From: [Dave Aube](#)
To: [Webb, Robert L.](#)
Cc: [Shannon VanDusen](#); [Emily Brudenell](#)
Subject: Re: 1300 Britt
Date: Wednesday, June 7, 2023 6:35:14 PM
Attachments: [image013.png](#)
[image014.png](#)
[image015.png](#)
[image016.png](#)
[image017.png](#)
[image.png](#)

DEVELOPMENT PLAN FOR 1300 BRITT

1300 Britt

I had a couple questions on the AA submittal.

SITE PLAN

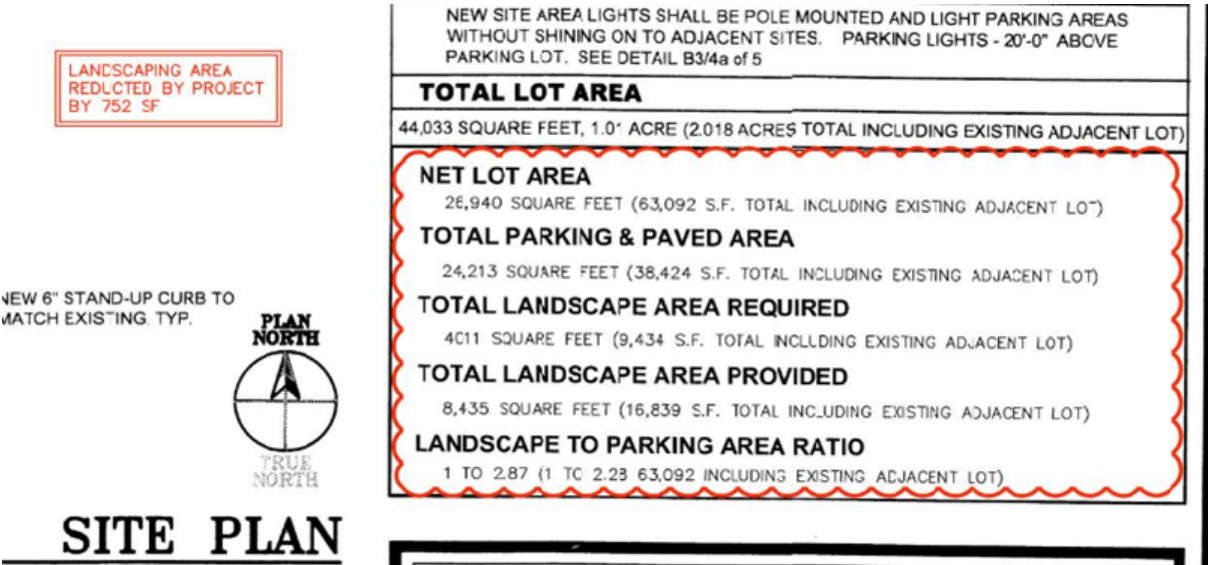
*Landscaping is being reduced.

Will it still meeting the standards of the original plan?

Or are you adding in another area?

As far as the Landscaping, we are proposing a reduction of 735 sf. We are required a total of 4011 sf, and will still have 8,435 sf on site.

Below are images from the AA we submitted that identify the required and provided totals. The image with the red revision clouds is the proposed condition. The black and white image is from the Site Plan from 2009.

As you can see the Net Lot area was slightly reduced (thus reducing the required sf). We are still well above the required and have reduced the provided landscaping by less than 10% (actually 8.2%).

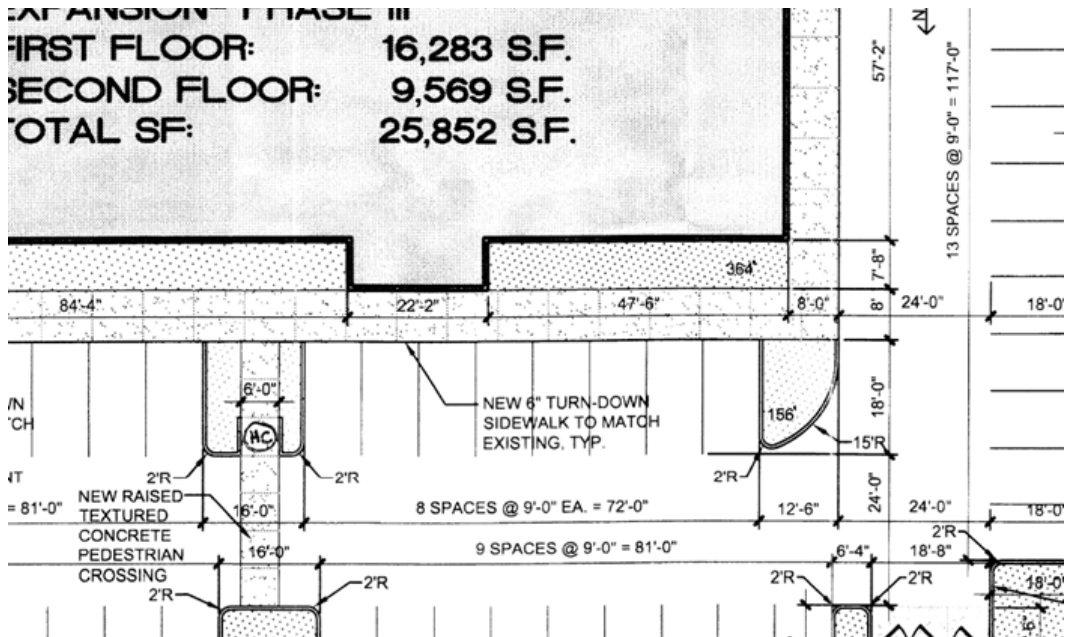
*Parking is being reduced

Is it meeting the standards of the original plan and/or the IDO?

Calculations?

*Parking is being reduced

Will it still meeting the standards of the original plan?

The parking is not being reduced. We are converting 7 standard size stalls to compact along the proposed building addition. They will be the only compact parking on site. We are still maintaining the 101 provided parking stalls.

As far as the parking, we are simply converting the standard parking stalls (8.5x18) to compact parking stalls (8.5x15) to give a little more room for the building addition.

The total number of compact spaces on the site will be 7 out of the required and provided 101.
